UNITED STATES PATENT AND TRADEMARK OFFICE

Office Action Summary	Application No.	Applicant(s)	
	09/891,200	SMOTKIN, EUGENE S.	
	Examiner	Art Unit	
	Raymond Alejandro	1745

DETAILED ACTION

FIG. 1

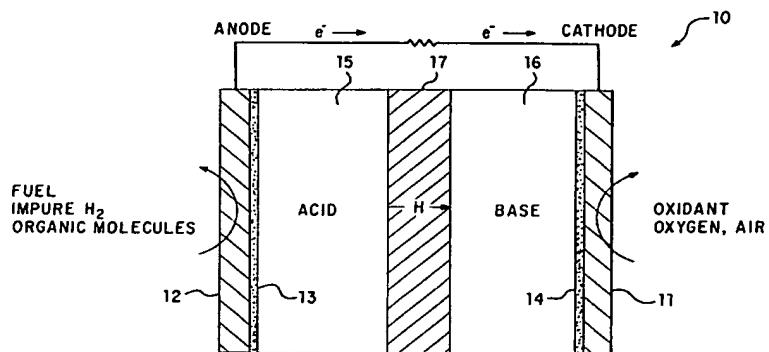
Figure 1 below illustrates the dense phase proton permeable material 17 separating acidic electrolyte-containing matrix layer 15 from basic electrolyte-containing matrix layer 16 (FIGURE 1/ COL 4, lines 44-55). It is disclosed that the dense phase proton permeably material comprises a foil of a metal hydride (COL 4, lines 57-64/ COL 3, lines 12-18). *Thus, the metal hydride foil serves as the support which is coated on both sides by respective electrolyte containing matrixes which represents the inorganic/composite non-liquid material.*

First Examiner's Note: since the recited "coating material" (i.e. "the inorganic or composite non-liquid material") covers a very large number of applicable materials which can be used therefor, it is also contended that "a coating material" comprising any non-liquid material would produce a component exhibiting the area-specific resistance (ASR) at the specific temperature range. Thus, such area-specific resistance (ASR) is an inherent characteristic or property of the respective electrolyte containing matrixes representing the inorganic/composite non-liquid material. That is, materials of at least similar compositions (i.e. any inorganic or composite non-liquid material) would be expected to have at least similar properties (See MPEP 2112: Requirements of Rejection Based on Inherency; Burden of Proof). Thus, the prior art coated component seems to be identical except that the prior art is silent as to an inherent property and/or characteristic. In that, it is noted that the extrinsic evidence makes clear that the missing descriptive matter is necessarily present in coated component described in the reference, and that it would be so recognized by persons of ordinary skill.

FIG. 1

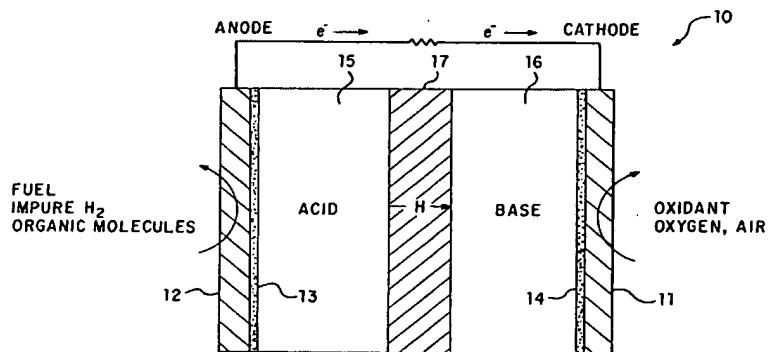
Figure 1 below illustrates the dense phase proton permeable material 17 separating acidic electrolyte-containing matrix layer 15 from basic electrolyte-containing matrix layer 16 (FIGURE 1/ COL 4, lines 44-55). It is disclosed that the dense phase proton permeably material comprises a foil of a metal hydride (COL 4, lines 57-64/ COL 3, lines 12-18). *Thus, the metal*

hydride foil serves as the support which is coated on both sides by respective electrolyte containing matrixes which represents the inorganic/composite non-liquid material.

First Examiner's Note: since the recited "coating material" (i.e. "the inorganic or composite non-liquid material") covers a very large number of applicable materials which can be used therefor, it is also contended that "a coating material" comprising any non-liquid material would produce a component exhibiting the area-specific resistance (ASR) at the specific temperature range. Thus, such area-specific resistance (ASR) is an inherent characteristic or property of the respective electrolyte containing matrixes representing the inorganic/composite non-liquid material. That is, materials of at least similar compositions (i.e. any inorganic or composite non-liquid material) would be expected to have at least similar properties (See MPEP 2112: Requirements of Rejection Based on Inherency; Burden of Proof). Thus, the prior art coated component seems to be identical except that the prior art is silent as to an inherent property and/or characteristic. In that, it is noted that the extrinsic evidence makes clear that the missing descriptive matter is necessarily present in coated component described in the reference, and that it would be so recognized by persons of ordinary skill.

FIG. 1

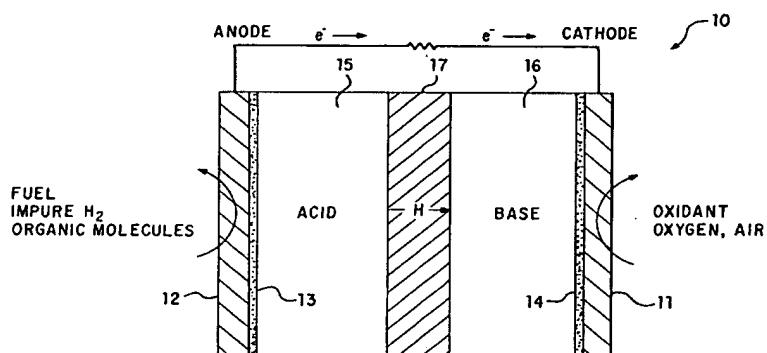
Figure 1 below illustrates the dense phase proton permeable material 17 separating acidic electrolyte-containing matrix layer 15 from basic electrolyte-containing matrix layer 16

(FIGURE 1/ COL 4, lines 44-55). It is disclosed that the dense phase proton permeable material comprises a foil of a metal hydride (COL 4, lines 57-64/ COL 3, lines 12-18). *Thus, the metal hydride foil serves as the support which is coated on both sides by respective electrolyte containing matrixes which represents the inorganic/composite non-liquid material.*

First Examiner's Note: since the recited "coating material" (i.e. "the inorganic or composite non-liquid material") covers a very large number of applicable materials which can be used therefor, it is also contended that "a coating material" comprising any non-liquid material would produce a component exhibiting the area-specific resistance (ASR) at the specific temperature range. Thus, such area-specific resistance (ASR) is an inherent characteristic or property of the respective electrolyte containing matrixes representing the inorganic/composite non-liquid material. That is, materials of at least similar compositions (i.e. any inorganic or composite non-liquid material) would be expected to have at least similar properties (See MPEP 2112: Requirements of Rejection Based on Inherency; Burden of Proof). Thus, the prior art coated component seems to be identical except that the prior art is silent as to an inherent property and/or characteristic. In that, it is noted that the extrinsic evidence makes clear that the

FIG. 1

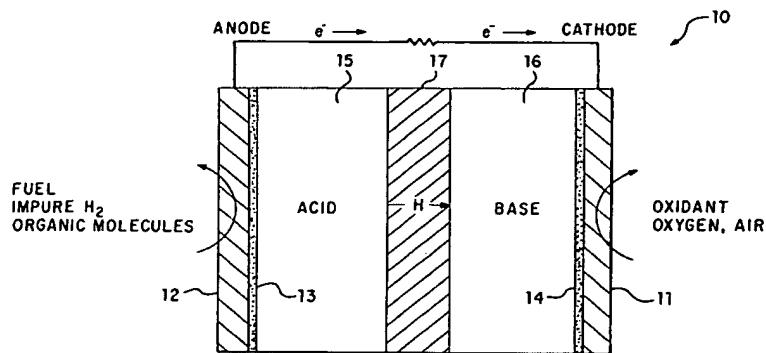
Figure 1 below illustrates the dense phase proton permeable material 17 separating acidic electrolyte-containing matrix layer 15 from basic electrolyte-containing matrix layer 16 (FIGURE 1/ COL 4, lines 44-55). It is disclosed that the dense phase proton permeably material comprises a foil of a metal hydride (COL 4, lines 57-64/ COL 3, lines 12-18). *Thus, the metal hydride foil serves as the support which is coated on both sides by respective electrolyte containing matrixes which represents the inorganic/composite non-liquid material.*

First Examiner's Note: since the recited "coating material" (i.e. "the inorganic or composite non-liquid material") covers a very large number of applicable materials which can be used therefor, it is also contended that "a coating material" comprising any non-liquid material would produce a component exhibiting the area-specific resistance (ASR) at the specific temperature range. Thus, such area-specific resistance (ASR) is an inherent characteristic or property of the respective electrolyte containing matrixes representing the inorganic/composite non-liquid material. That is, materials of at least similar compositions (i.e. any inorganic or composite non-liquid material) would be expected to have at least similar properties (See MPEP 2112: Requirements of Rejection Based on Inherency; Burden of Proof). Thus, the prior art coated component seems to be identical except that the prior art is silent as to an inherent property and/or characteristic. In that, it is noted that the extrinsic evidence makes clear that the missing descriptive matter is necessarily present in coated component described in the reference, and that it would be so recognized by persons of ordinary skill.

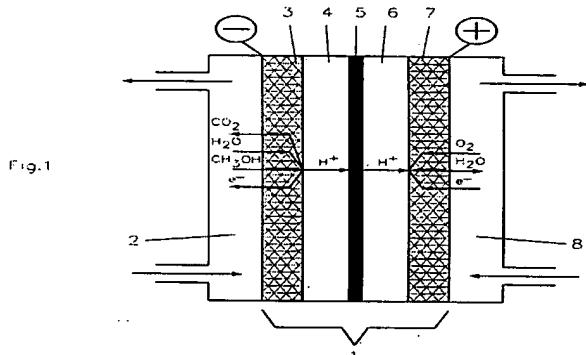
Figure 1 below illustrates the palladium silver alloy foil layer 5 the two non-liquid electrolyte layers 4 and 6 (FIGURE 1). *Thus, the palladium silver alloy foil layer serves as the support which is coated on both sides by respective electrolyte layers which represents the inorganic/composite non-liquid material.*

First Examiner’s Note: since the recited “coating material” (i.e. “the inorganic or composite non-liquid material”) covers a very large number of applicable materials which can be used therefor, it is also contended that “a coating material” comprising any non-liquid material would produce a component exhibiting the area-specific resistance (ASR) at the specific

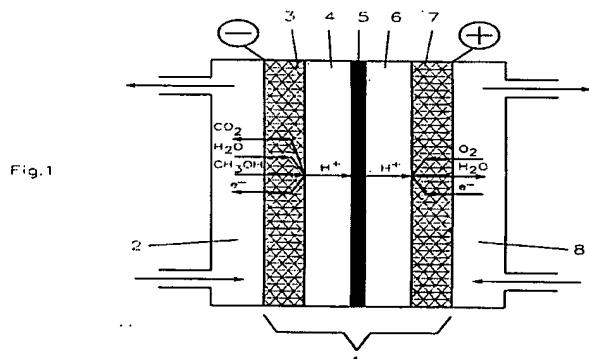
Figure 1 below illustrates the palladium silver alloy foil layer 5 the two non-liquid electrolyte layers 4 and 6 (FIGURE 1). *Thus, the palladium silver alloy foil layer serves as the support which is coated on both sides by respective electrolyte layers which represents the inorganic/composite non-liquid material.*

First Examiner’s Note: since the recited “coating material” (i.e. “the inorganic or composite non-liquid material”) covers a very large number of applicable materials which can

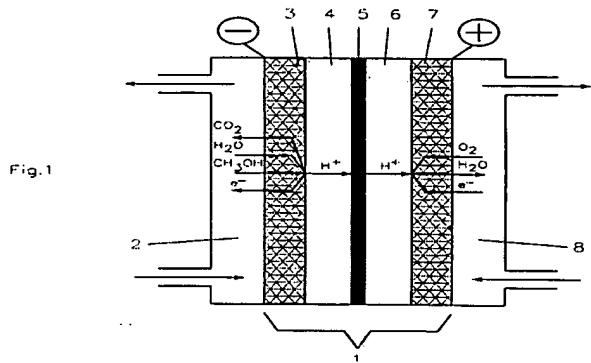
Figure 1 below illustrates the palladium silver alloy foil layer 5 the two non-liquid electrolyte layers 4 and 6 (FIGURE 1). *Thus, the palladium silver alloy foil layer serves as the support which is coated on both sides by respective electrolyte layers which represents the inorganic/composite non-liquid material.*

First Examiner's Note: since the recited "coating material" (i.e. "the inorganic or composite non-liquid material") covers a very large number of applicable materials which can be used therefor, it is also contended that "a coating material" comprising any non-liquid material would produce a component exhibiting the area-specific resistance (ASR) at the specific temperature range. Thus, such area-specific resistance (ASR) is an inherent characteristic or property of the respective electrolyte containing matrixes representing the inorganic/composite non-liquid material. That is, materials of at least similar compositions (i.e. any inorganic or composite non-liquid material) would be expected to have at least similar properties (See MPEP 2112: Requirements of Rejection Based on Inherency; Burden of Proof). Thus, the prior art coated component seems to be identical except that the prior art is silent as to an inherent property and/or characteristic. In that, it is noted that the extrinsic evidence makes clear that the missing descriptive matter is necessarily present in coated component described in the reference, and that it would be so recognized by persons of ordinary skill.

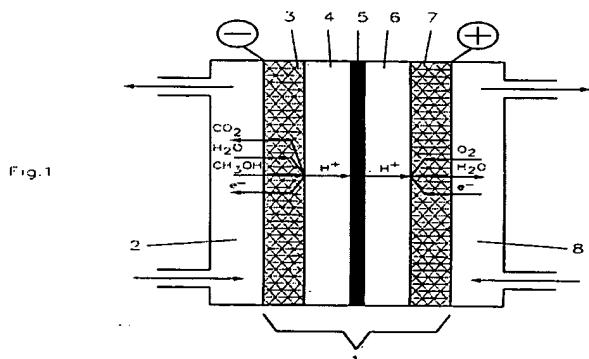
Figure 1 below illustrates the palladium silver alloy foil layer 5 the two non-liquid electrolyte layers 4 and 6 (FIGURE 1). *Thus, the palladium silver alloy foil layer serves as the support which is coated on both sides by respective electrolyte layers which represents the inorganic/composite non-liquid material.*

First Examiner's Note: since the recited "coating material" (i.e. "the inorganic or composite non-liquid material") covers a very large number of applicable materials which can be used therefor, it is also contended that "a coating material" comprising any non-liquid material would produce a component exhibiting the area-specific resistance (ASR) at the specific temperature range. Thus, such area-specific resistance (ASR) is an inherent characteristic or property of the respective electrolyte containing matrixes representing the inorganic/composite non-liquid material. That is, materials of at least similar compositions (i.e. any inorganic or composite non-liquid material) would be expected to have at least similar properties (See MPEP 2112: Requirements of Rejection Based on Inherency; Burden of Proof). Thus, the prior art coated component seems to be identical except that the prior art is silent as to an inherent property and/or characteristic. In that, it is noted that the extrinsic evidence makes clear that the missing descriptive matter is necessarily present in coated component described in the reference, and that it would be so recognized by persons of ordinary skill.
